## TENDER 19-07

### WATERFRONT SEWER UPGRADES PHASE II

#### ADDENDUM NO. 4

TITLE:  
**CITY OF CAMPBELL RIVER**  
WATERFRONT SEWER SYSTEM UPGRADES - PH 2  
CAMPBELL RIVER, BC  
HWY 19A  
DETAILS SHEET

SHEET 8 OF 8

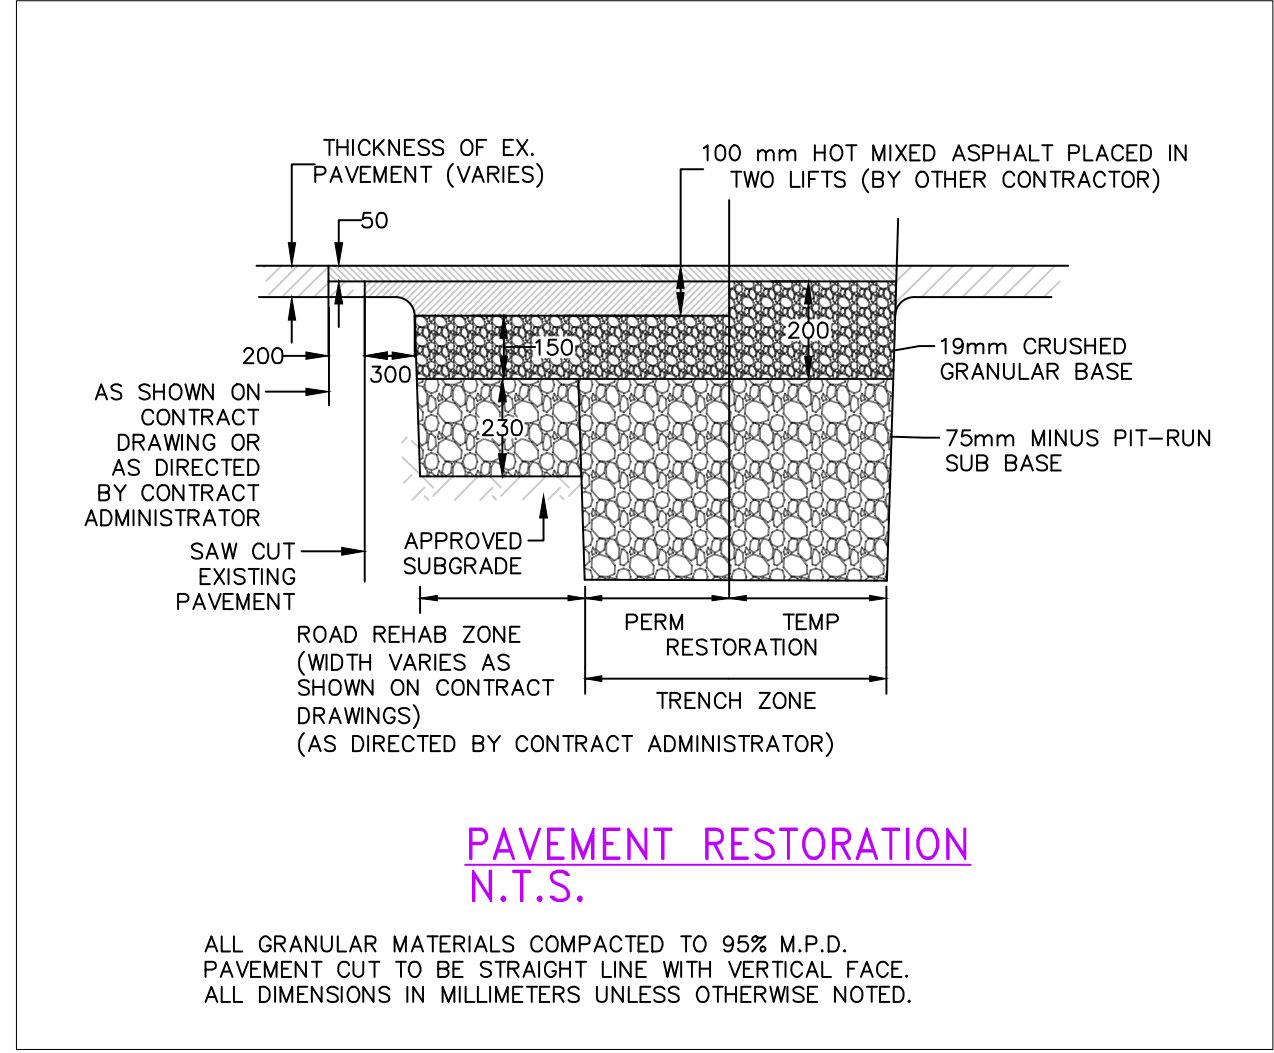
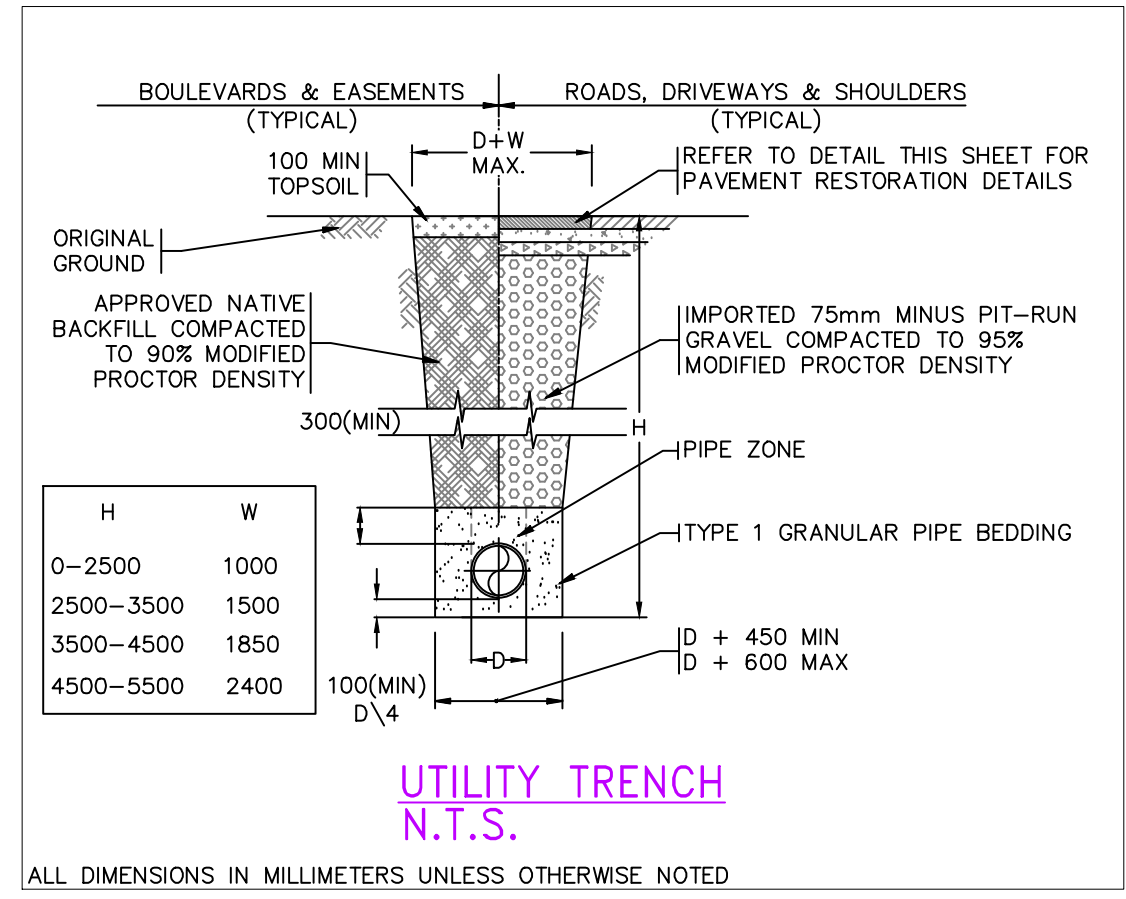
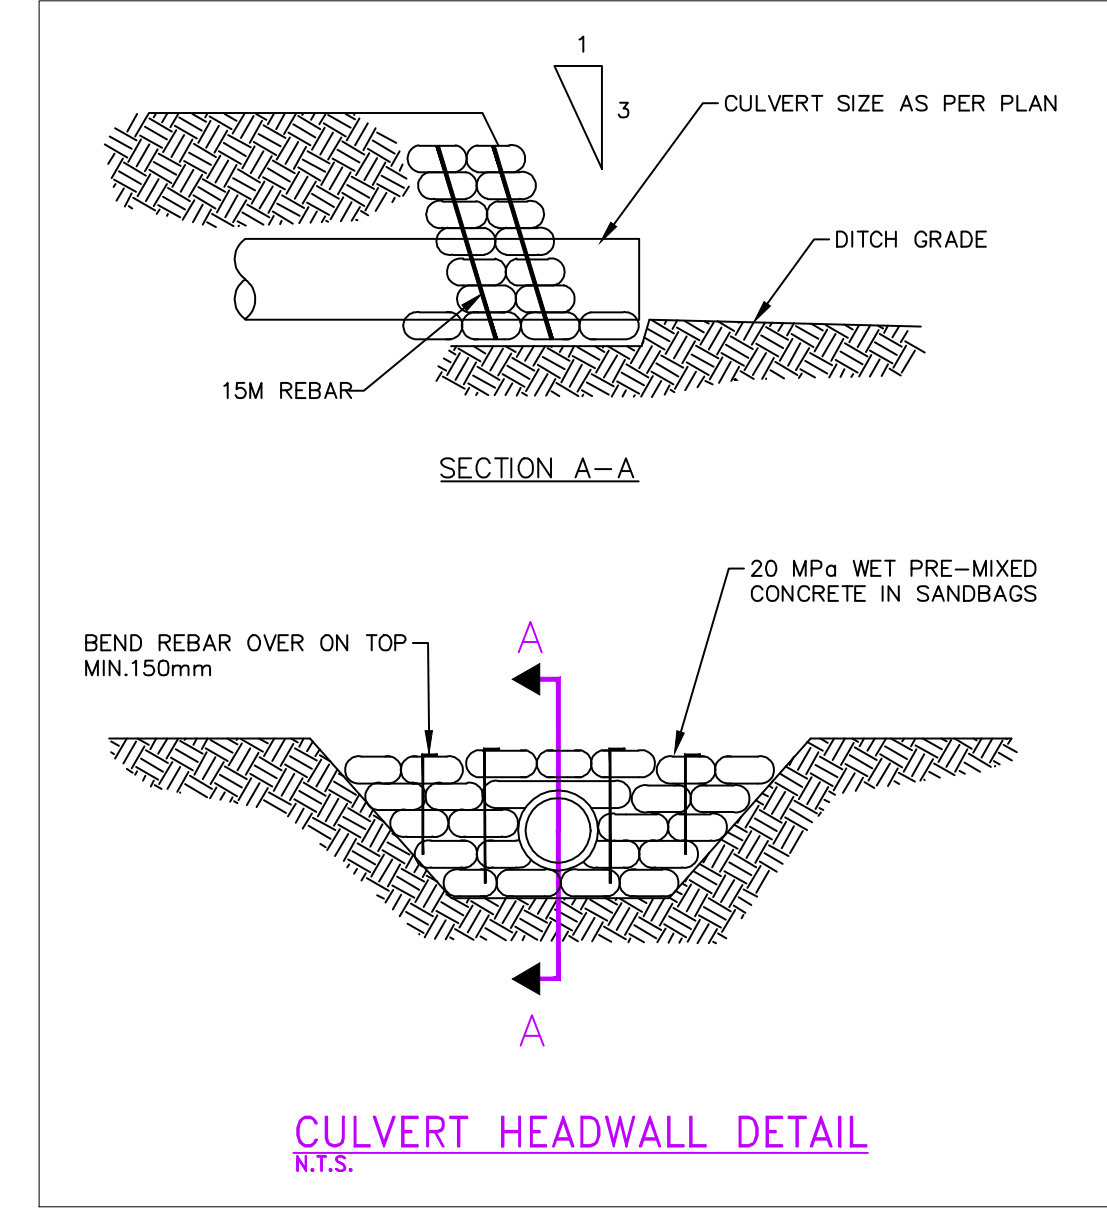
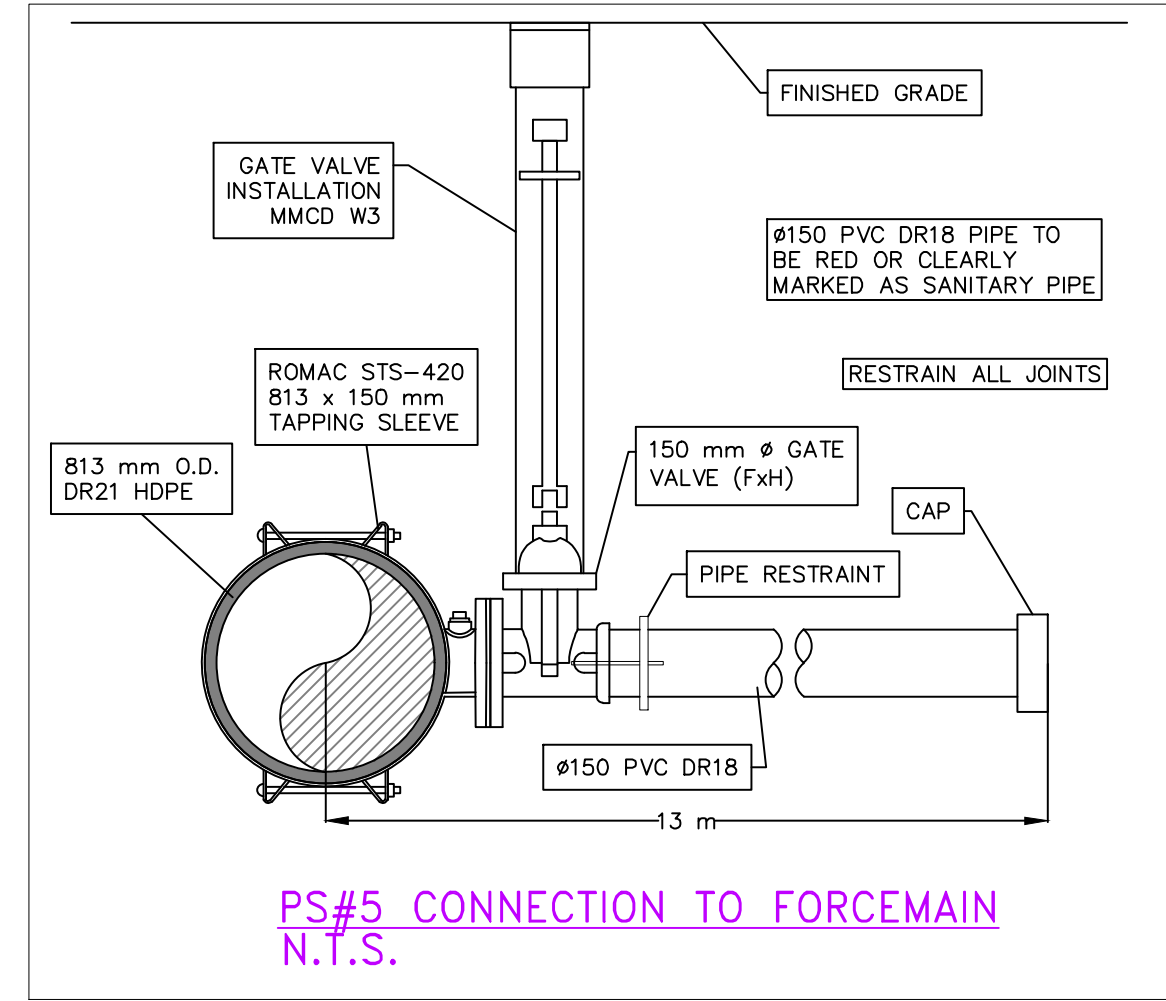
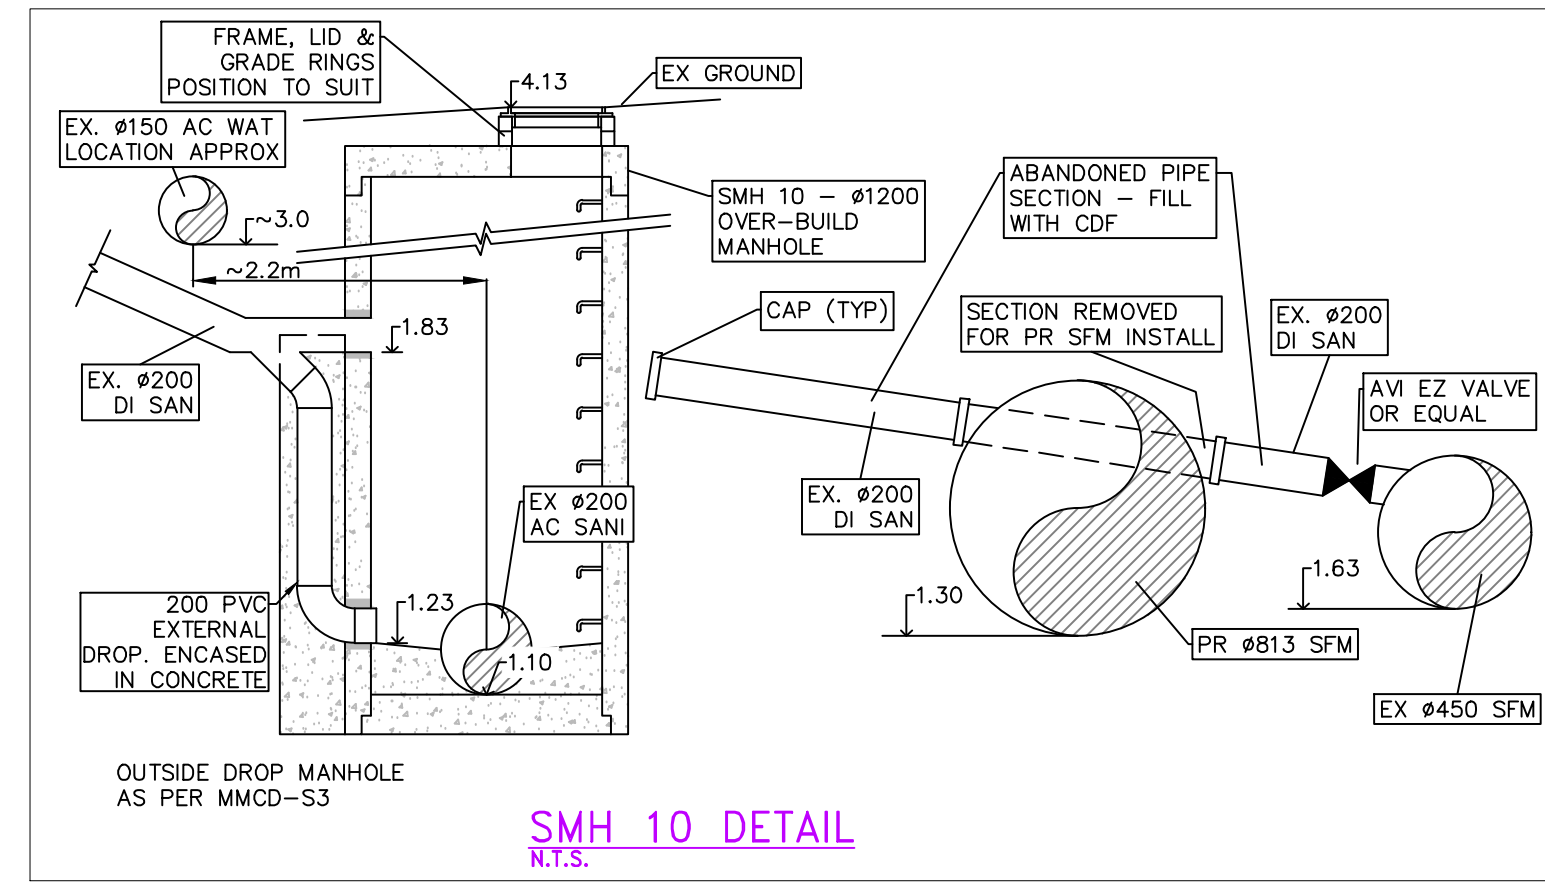
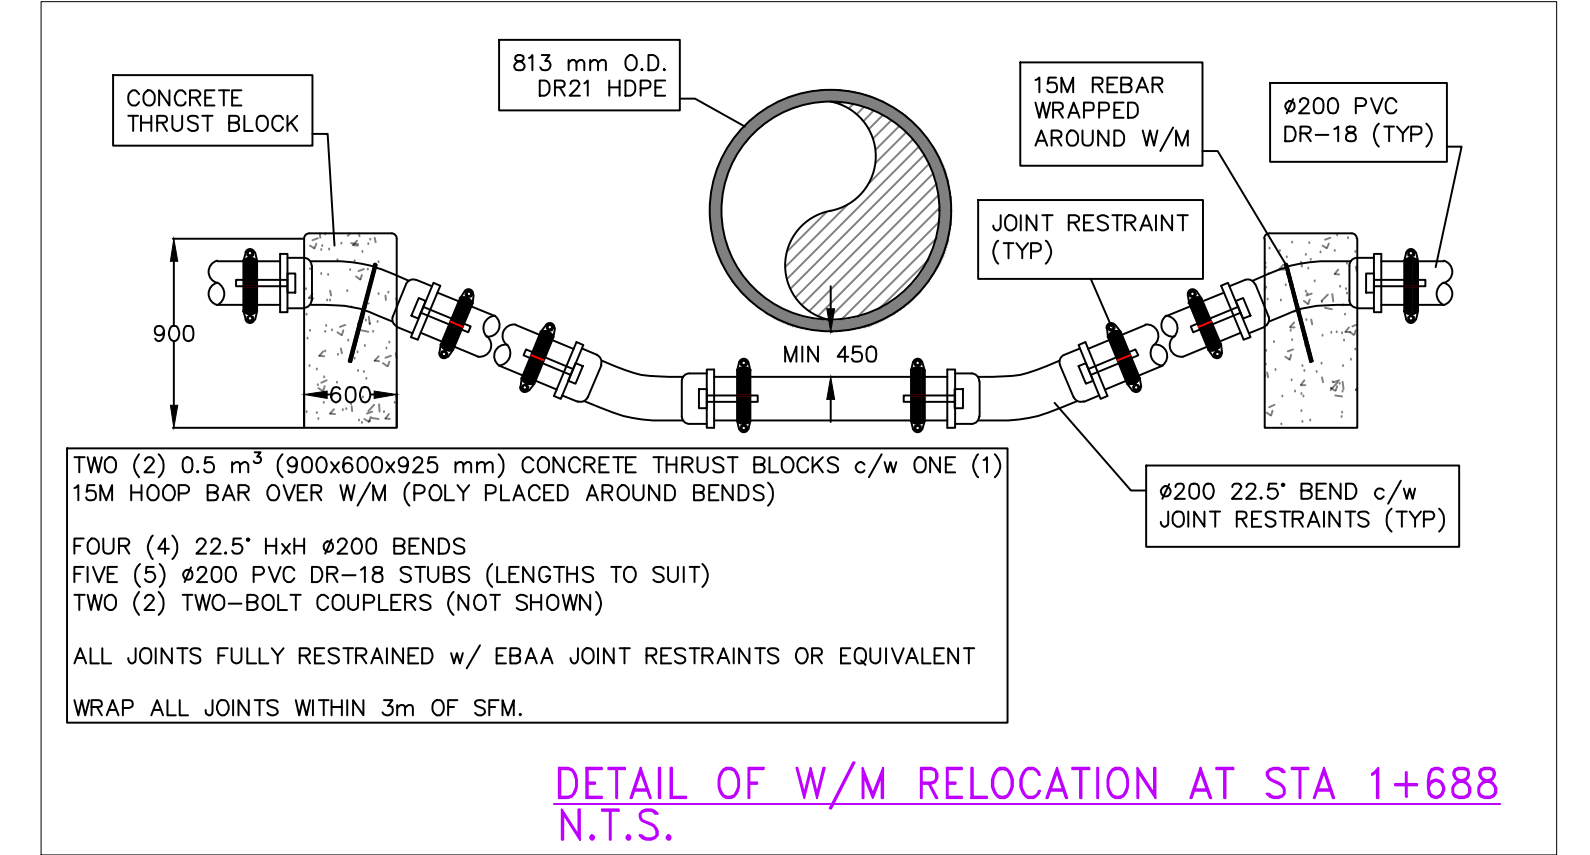
I'm told by suppliers that the 813mm x 200mm FxF SCH40 reducer detailed in the FORCEMAIN LOW POINT DRAIN DETAIL on drawing 8 of 8, cannot be manufactured. Could you consider a re-design to this item?

A similar connection is detailed within the 19-08 tender drawings as a 750mm blind flange c/w 200 IPT and ss 200mm spool that is threaded on one end and flanged on the other. These parts appear to be readily available.

With reference to Addendum #3, Q&A #3, there are no 200mm HH gate valves on the low point drains. Your detail on Sheet 8 shows 1 each of 200mm FF and 200mm HF gate valves.

Bid Item #43 (Appendix 1B) and detail "PH #3 TIE-IN DETAIL" on Sheet 8 would be applicable for this contract Option 1 and not Option 2. Where is the payment item for an Option 2 (750mm) tie-in at 0+000?

Replace the 813 mm x 200 mm FxF SCH40 reducer with a 750 mm x 200 mm FxF SCH40 spool as per the revised detail on Sheet 8 of 8 attached.

See sheet 8 of 8 rev D, where there are 200 mm H x H gate valves.

---	---	---	---	T	U/G TELEPHONE	T	S	SANITARY SEWER	---	S	O.D.	OPEN DITCH	---	O.D.
---	---	---	---	H	U/G HYDRO	H	D	STORM DRAIN	---	D	SMH	SANITARY MANHOLE	---	SMH
---	---	---	---	G	NATURAL GAS	G	W	WATER MAIN	---	W	DMH	STORM MANHOLE	---	DMH
D	LOW POINT DRAIN DETAIL CHANGED	FG	19/04/08	P	PERMEABLE PAVING	P	C	CURB & GUTTER	---	C	---	CATCH BASIN	---	---
B	DETAILS CHANGED	FG	19/03/28	---	---	---	---	---	---	---	---	---	---	---
B	DETAIL ADDED	FG	19/09/20	---	---	---	---	---	---	---	---	---	---	---
A	ISSUED FOR TENDER	FG	19/03/12	---	---	---	---	---	---	---	---	---	---	---
